Final Drainage Report
for
Rolling Hills Ranch Filing 2
at
Meridian Ranch

EL PASO COUNTY, COLORADO

SF2020 Revised

PCD Project No. SF-19-023

Figure 2: FEMA Floodplain Map

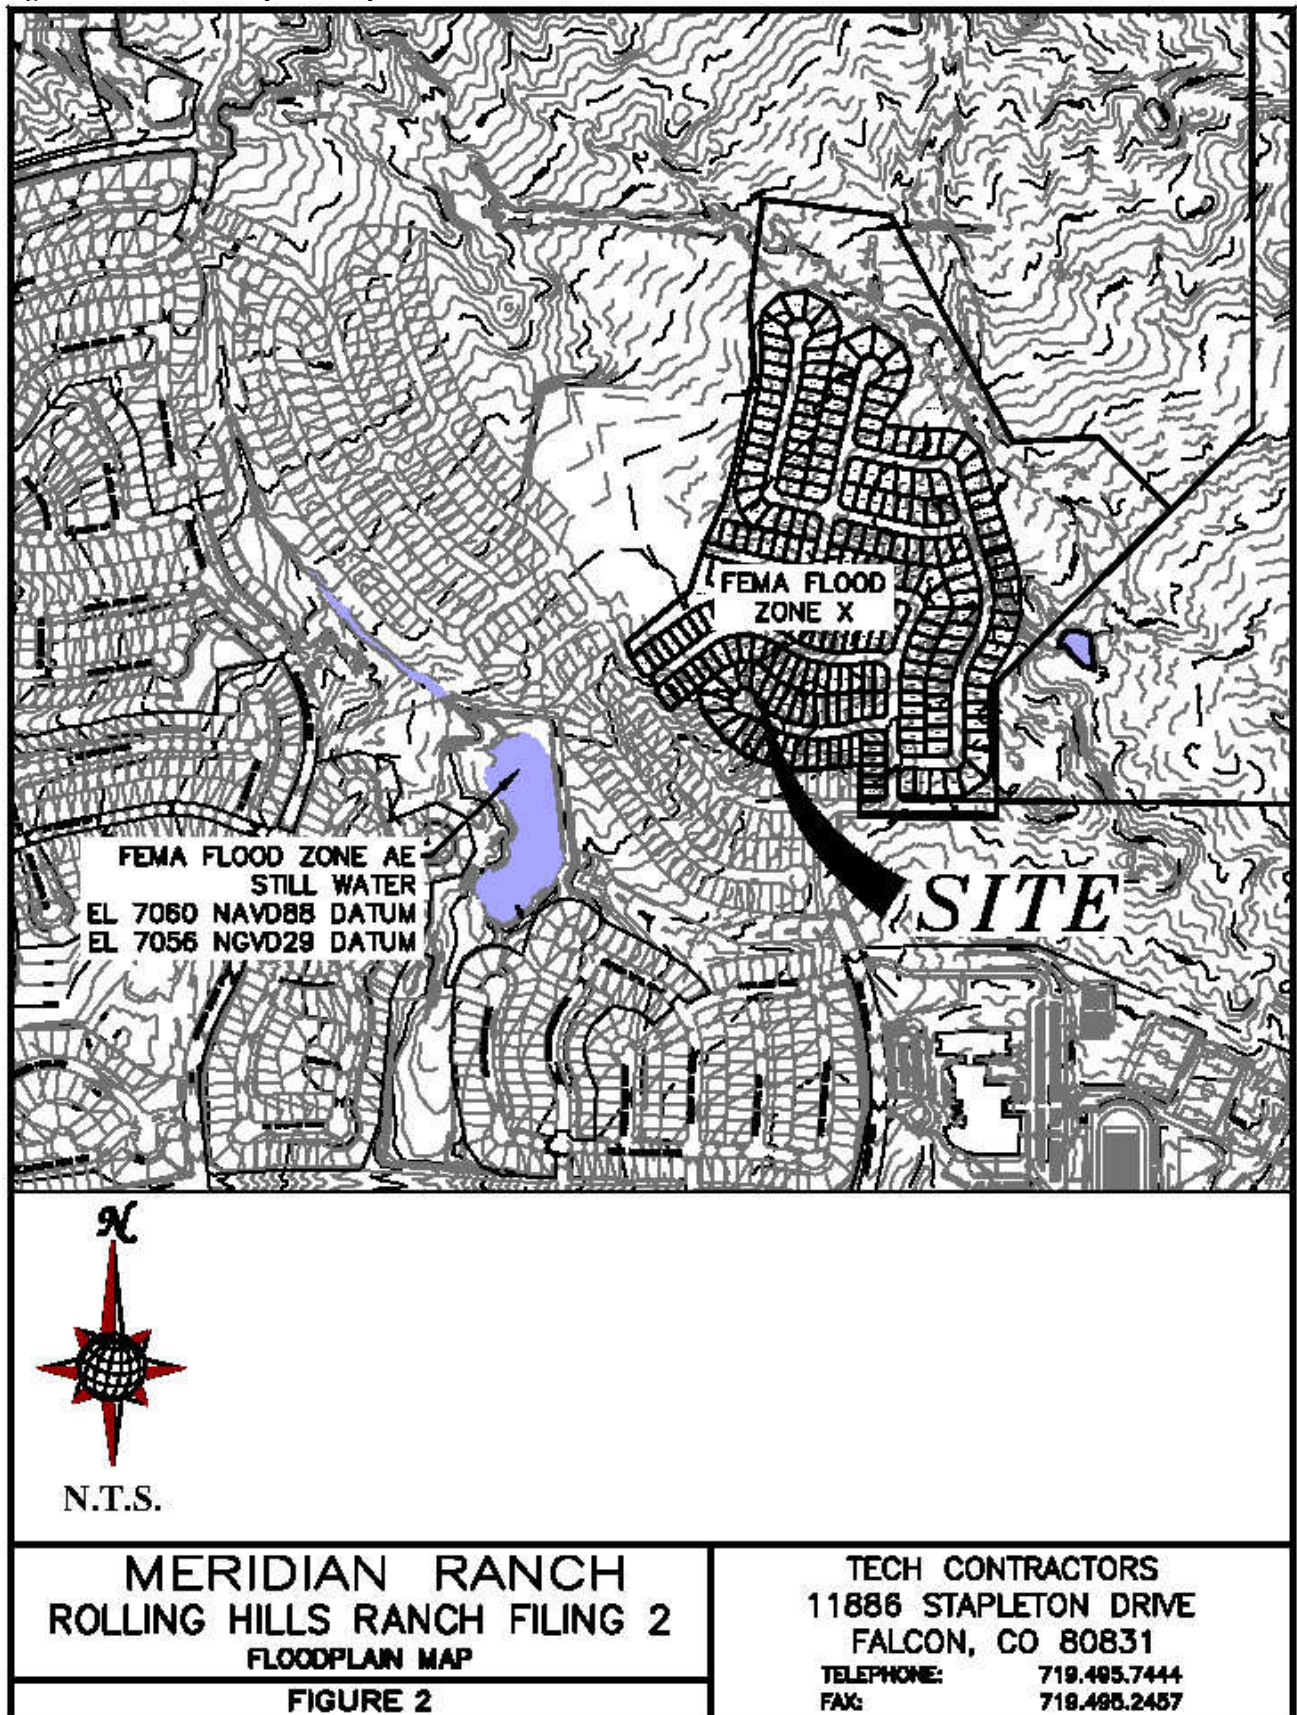
The title in Figure 2 indicates Rolling Hills Ranch Filing 2. Please revise

Revised

Figure 9-43. Modified impact stilling

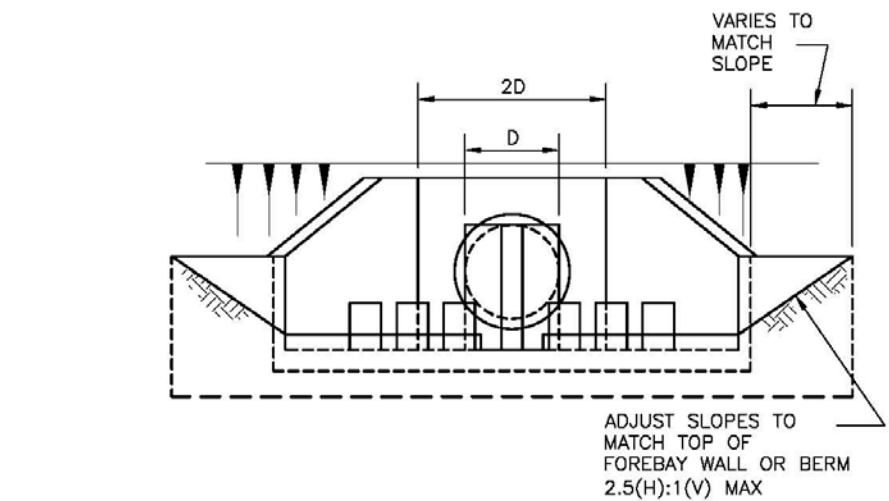
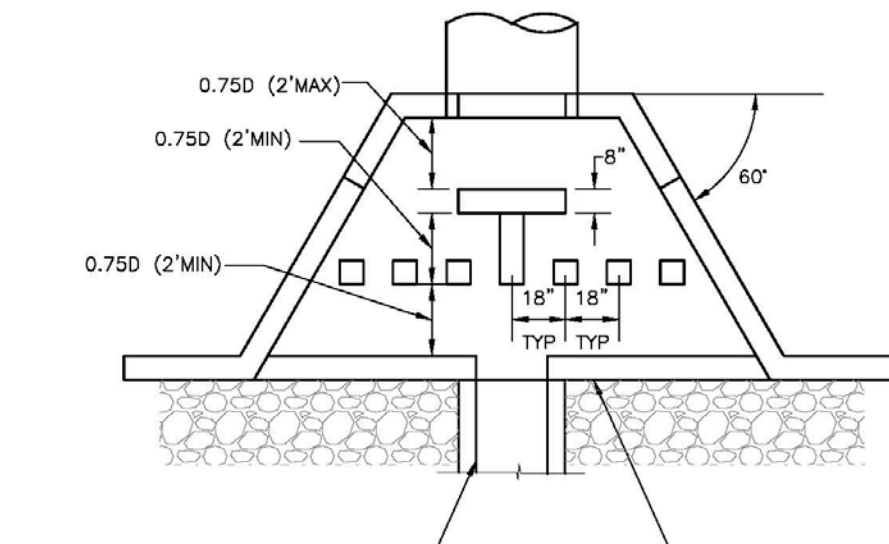
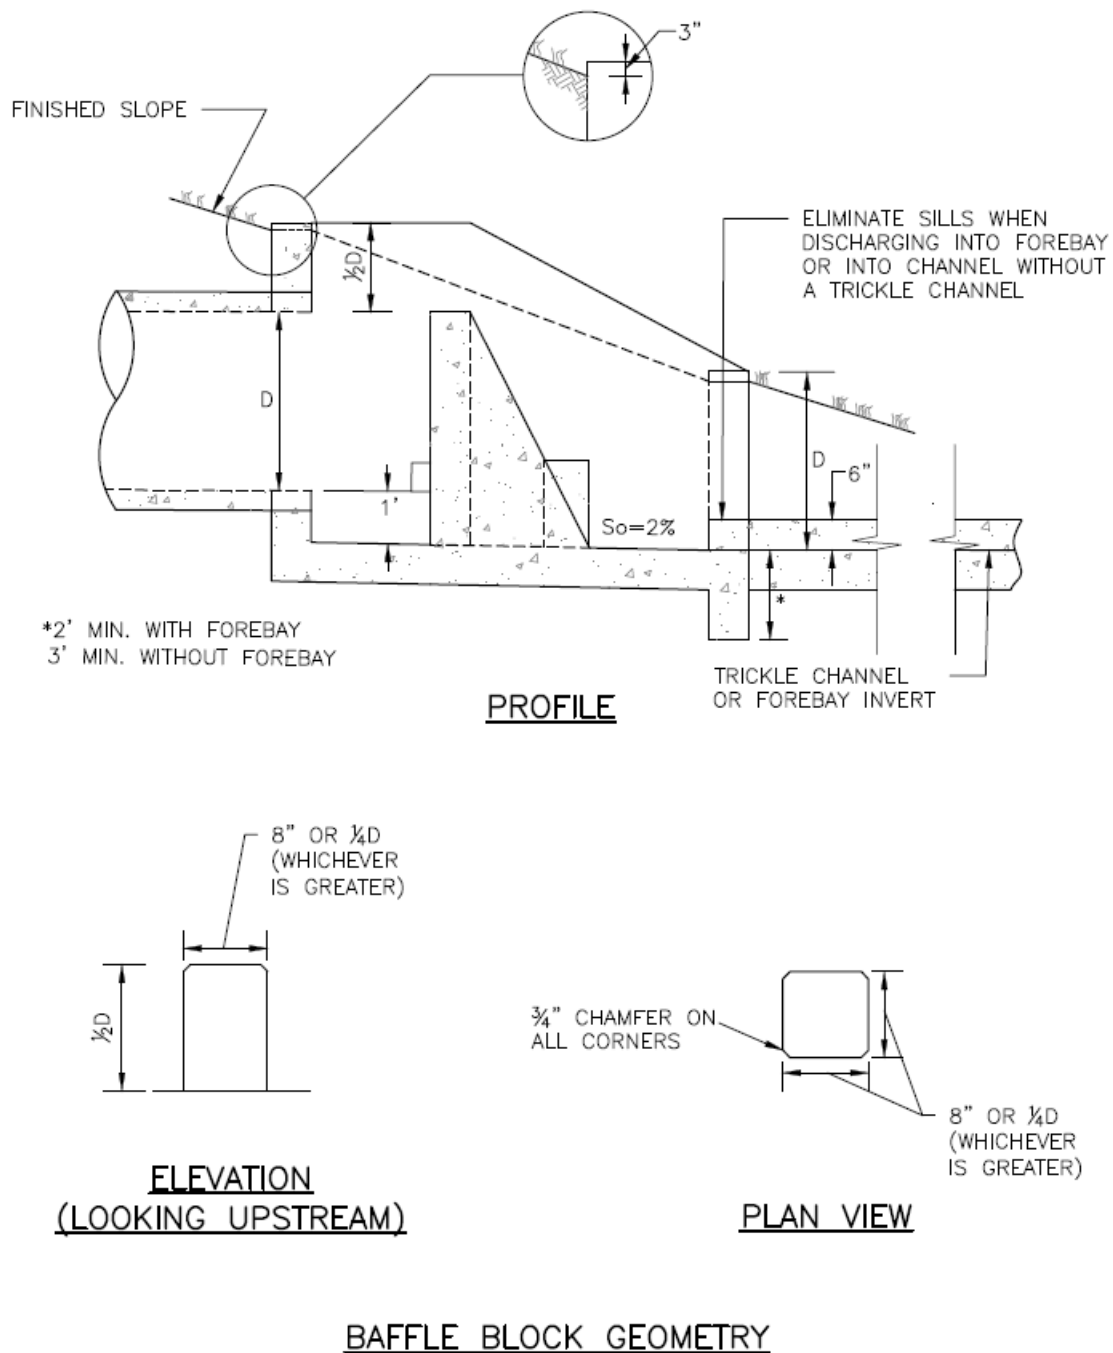
This is for conduits up to 48". The proposed conduit is 54". It appears that figure 9-45 of Urban Drainage Volume 2 (pg9-84) may be required.

Revise accordingly.

SPECIFIC DESIGN MODIFICATIONS WERE MADE TO THIS UDFCD STANDARD DETAIL TO ACCOMMODATE A 54" RCP. THIS ENERGY IMPACT DISSIPATER WAS SELECTED AND MODIFIED AS IT PROVES TO BE EASIER TO MAINTAIN CLEAR DEPOSITED SEDIMENT. THE ENGINEER OF RECORD BELIEVES THIS IS A SUPERIOR DESIGN OVER THE MODIFIED USBR TYPE VI IMPACT STILLING BASIN.

NO CHANGE

HISTORICAL CONDITIONS - SCS MAP

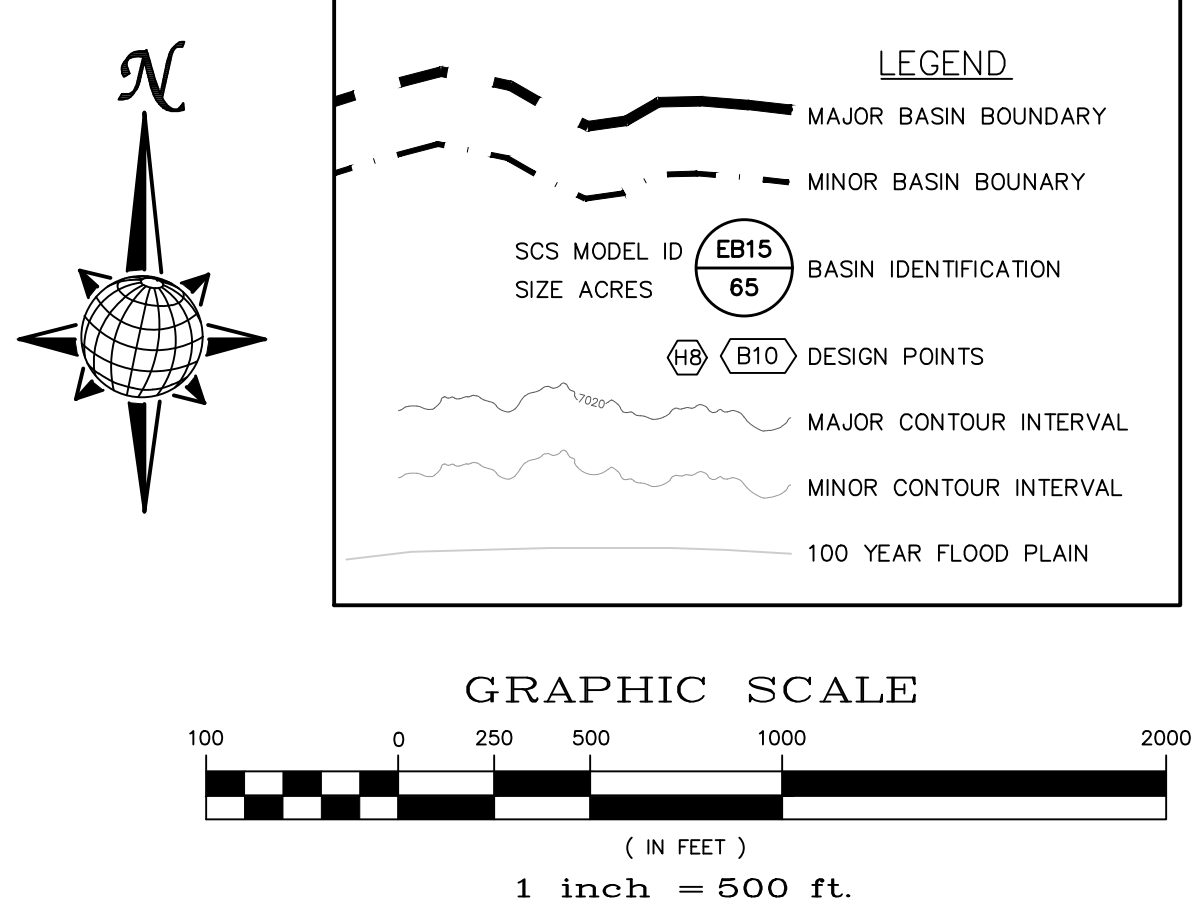
Filing 2 is not readily apparent. Please add a hatch/color for the filing 2 area. Additionally please label the existing ponds (include pond data as done in RHR#1). Please do the same for the future conditions map.

It appears that the SCS Maps are missing the "Figure" label. Please add it to the corresponding map.

REVISIED
